MASTER REVIEW REPORT

CASE NUMBER: C814-2018-0121  
CASE MANAGER: Heather Chaffin                      PHONE #: 512-974-2122

PROJECT NAME: 218 S. Lamar

LOCATION: 218 SOUTH LAMAR

**4-Lane Divided, 60' Curb-to-Curb  
Back-of-Curb Condition F  
Barton Springs Road to Riverside Drive**

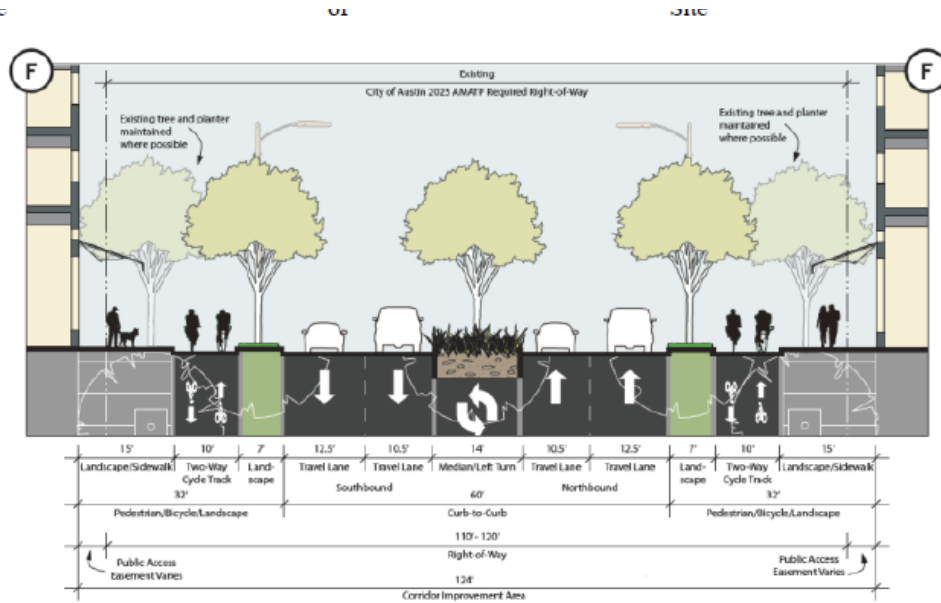
TR2. Include the below streetscape in the land use plan. Contact this reviewer for a more legible copy of it if necessary. This project is adjacent to a street that has been identified in Austin's Corridor Mobility Program (S Lamar). The sidewalk and bicycle facilities shall comply with the required cross-section at the time of the site plan application. The cross section that will be required is shown below. Find additional information about the Corridor Mobility Program here: <https://data.austintexas.gov/stories/s/Corridor-Mobility-Program/gukj-e8fh/>. Any proposed curb relocations on S Lamar requires coordination with the Corridor Planning Office and Bicycle Program. The cross section will include a 7' planting zone with street trees, a 10' two-way cycle track, and a 15' clear zone all behind curb. Additionally, a protected intersection will be required at Toomey, to be reviewed at the time of Site Plan.
